# RFP for Category 6A ISO Structured Cabling System

Town of Orono  
59 Main Street  
Orono, Maine 04473

RFP For Cabling Renovation Town Office Building 2020

**Edits to RFP released on 04/24/2020:**

Figure 1: Hole in the floor between first and second floors showing existing cabling.  
Assume 12 inch thick floor

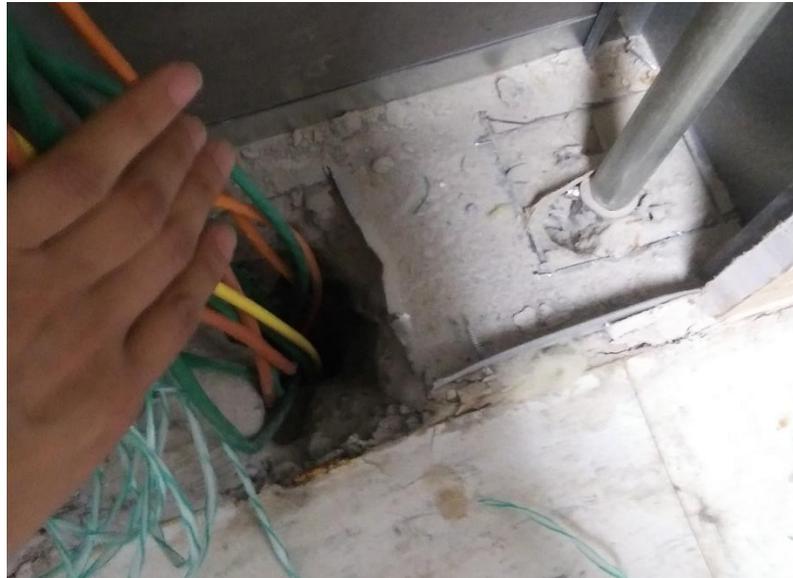
Option 4: Provide a separate line item for drilling hole through floor and wall. Figure 1 shows existing hole that needs to be widened going from second floor to first floor.
